Access Compliance Report Public Rights-of-Way (Pedestrian Signals)

Main Street: **BATAVIA_ST** Cross Street: **LINCOLN_AVE** Location: **SW**

ADA ID: **SGAT210924094654** Signal Type: **One Push Button-APS** Overall Compliance: **No** Severity Scores: **BTN 1: 25** **BTN 2: N/A** **No BTN: N/A**

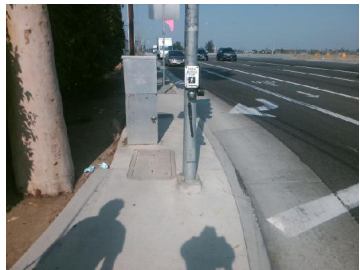
OC Std/PROW: **R404.2**

Possible Solutions: Remove and Replace Clear Space.
